# STEREO IMPACT

PROBLEM REPORT

PR-1001

QualBoomDeploy

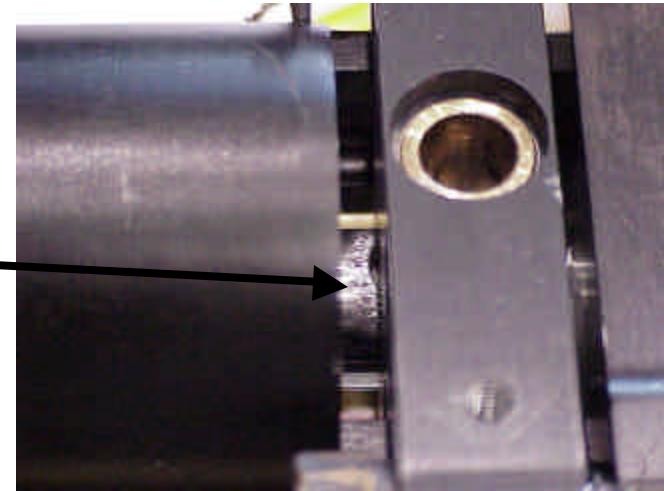
- The mount is used to preload the tubes for resisting launch loads. There are 2 fixed pivots, and a coil spring used to apply the load to the tip piece tail. The release of the SMAR pinpuller allowed the coil spring to unload faster than the tip piece could clear the floating mount. This induced a tilt to the mount.

Due to the tight tolerance required, there was insufficient room for the tip piece to withdraw from the mount, and thus became locked into the SMAR mount.

- This was not seen during the previous anomaly as the latching had been released when the safety pin was installed
- Close inspection revealed galling of the Ti tip piece, as wear had accumulated from deploying. The mount functioned as a sliding clamp, with 2 edges grabbing the tip piece. The second picture shows the wear on the mount from hanging up the tip.

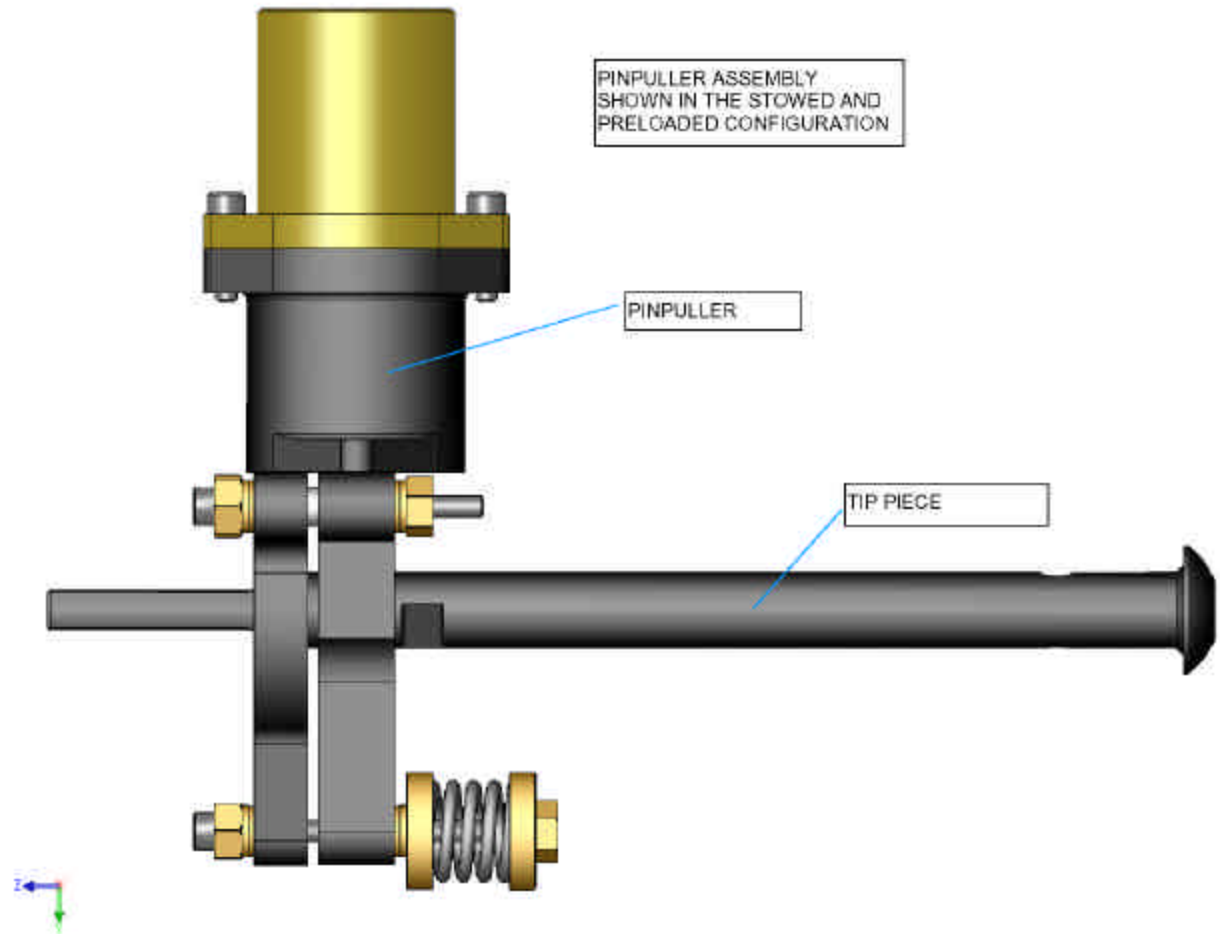
- The solid model was re-examined for verification of the anomalous condition
- This first drawing shows the affected parts, in their stowed, nominal condition

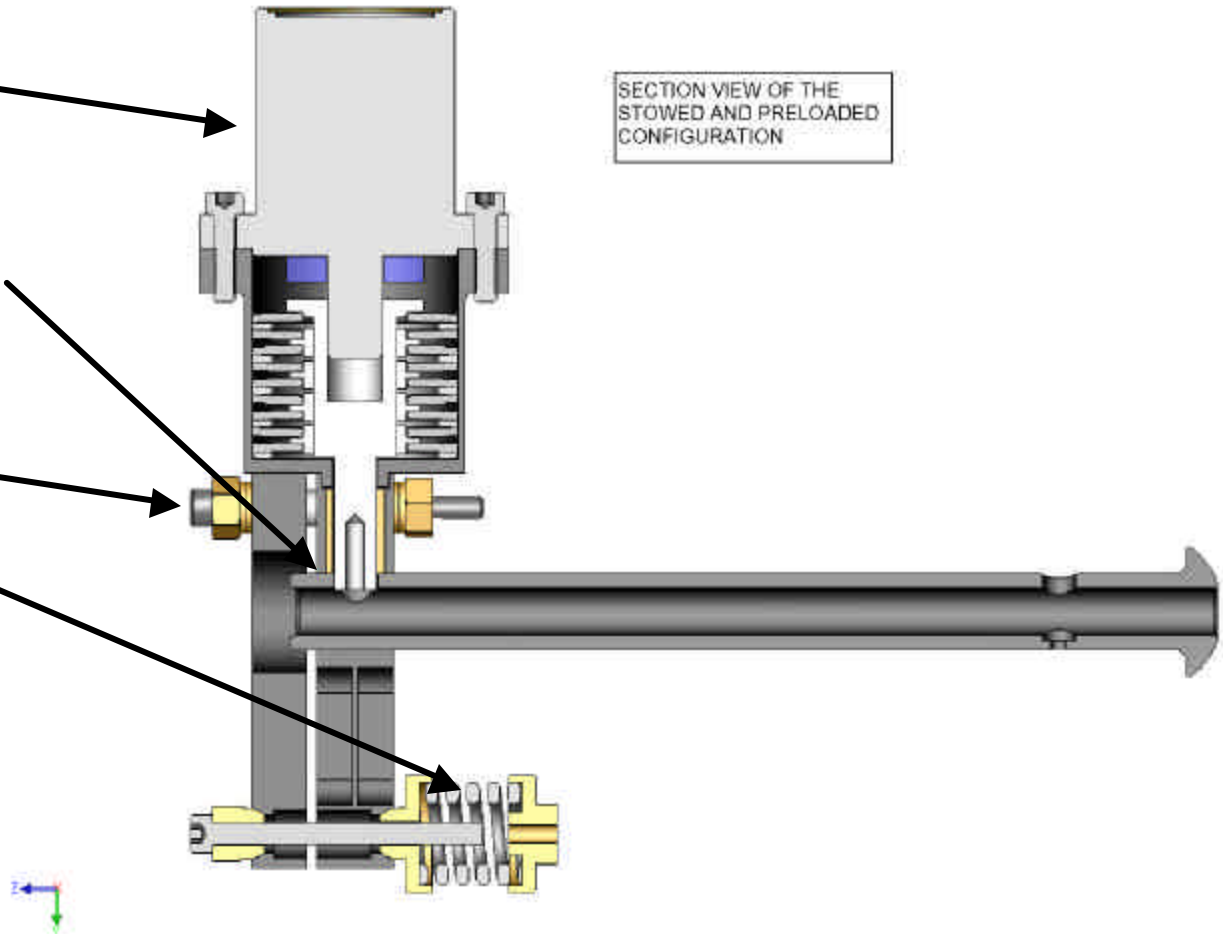
- Same drawing, section view

- Note the close fit of the tip piece to the floating mount, where the SMAR pinpuller is inserted into the tip piece.

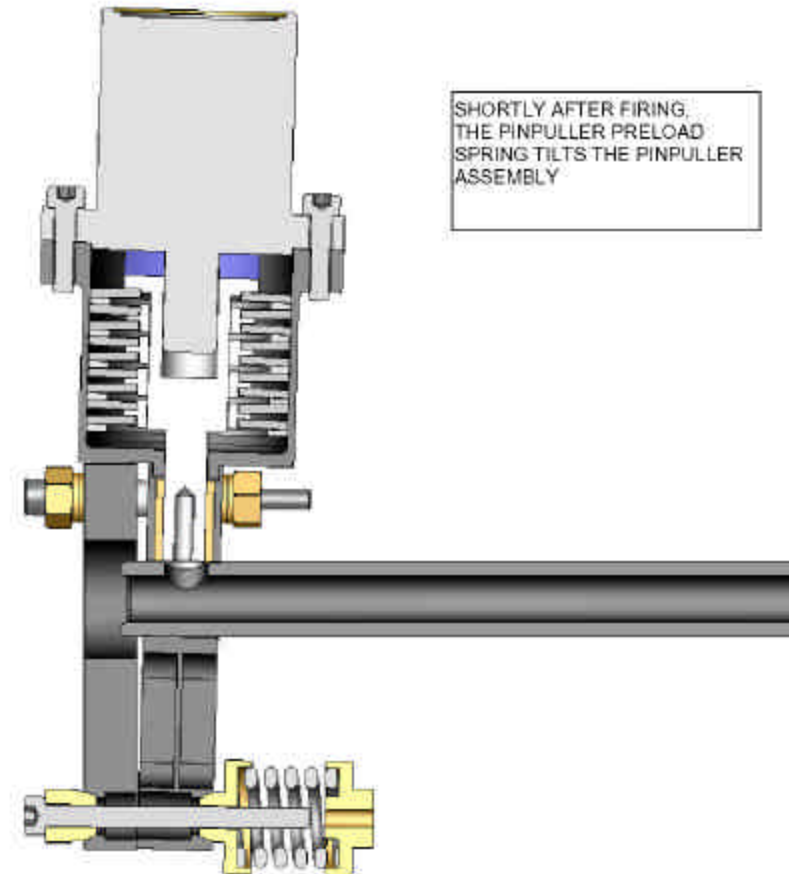
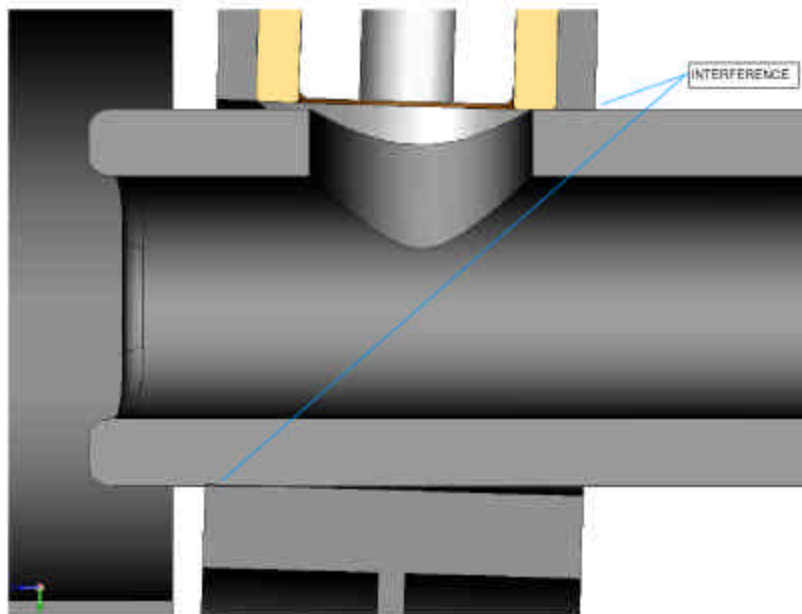
- This drawing is the section view, post SMAR firing
- Coil preload spring has pushed the mount against the housing sooner than the tip piece can clear the through hole.
- The tip piece binds in the mount (detail)

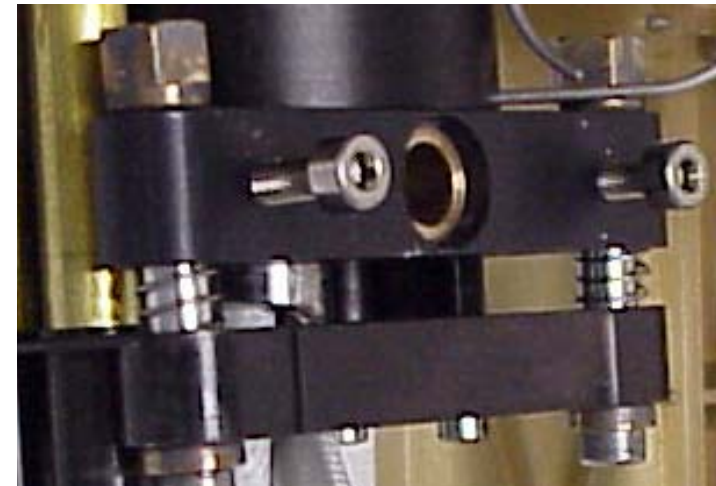
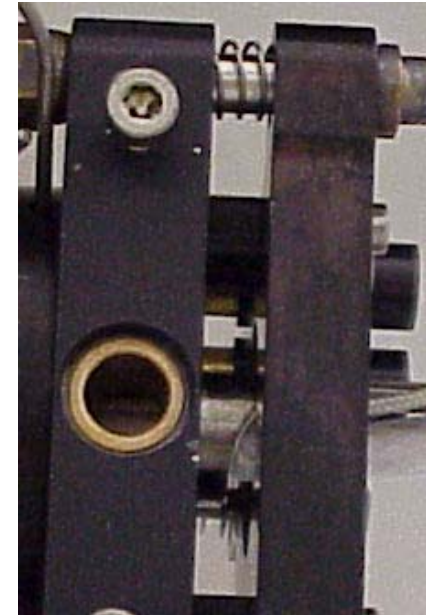
- **After successful deployment of the boom (cold) and Thermal Balance, the boom was disassembled and inspected to look for signs of galling**
- **The pinpuller is removed to increase the viewable area.**
- **Pictures show the tip piece to be free of the markings associated with galling as previously seen.**
- **The tip piece previously showed longitudinal streaks from the "teeth" generated by the galled aluminum in the deployment fixture.**

- This picture shows the modification as viewed along the tip piece. The opening that was added to provide clearance is now seen at the bottom of the picture.

- These pictures show that the modifications done to the pinpuller mounting ring are sufficient to remove the galling between it and the tip piece.
